PCN #191
Notification Date:
June 19, 2020

Product / Process Change Notice

Chip process CP771, P-channel MOSFETs, wafers and bare die.

Figure 1: CP771 Chip Geometry (Discontinued)

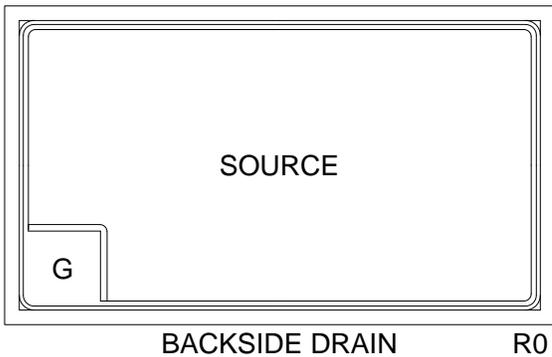
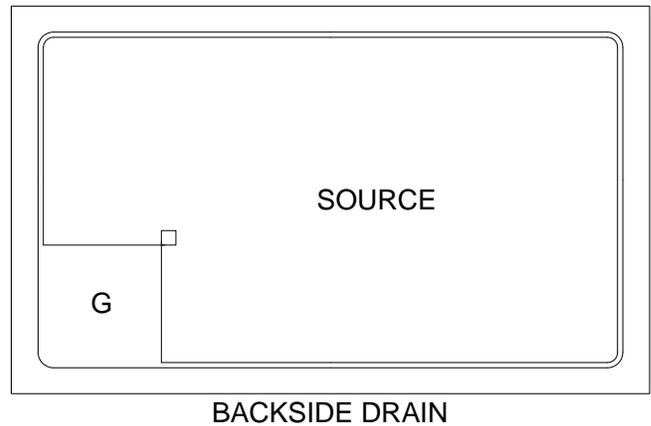
The CP771 wafer process has been discontinued and is being replaced with the CP805 wafer process. See Figures 1 and 2 for details.

The CP771 wafer process has been replaced in order to enhance manufacturing process controls and device performance. This change will help ensure an undisrupted supply of product.

The CP805 wafer process meets all electrical specifications of the individual devices listed on the following page.

Wafer Diameter: 8 inch
Die Size: 55 x 32 mils
Die Thickness: 7.5 mils
Bond Pad Size (Gate): 7.3 x 7.3 mils
Bond Pad Size (Source): 50 x 25 mils
Topside Metal: Al (40,000Å)
Backside Metal: Ti/Ni/Ag (1,000Å/3,000Å/10,000Å)

Wafer Diameter: 8 inch
Die Size: 63.8 X 38.9 mils
Die Thickness: 5.5 mils
Bond Pad Size (Gate): 7.1 x 7.1 mils
Bond Pad Size (Source): 60.4 x 35.6 mils
Topside Metal: Al-Cu (40,000Å)
Backside Metal: Ti/Ni/Ag (1,000Å/3,000Å/10,000Å)
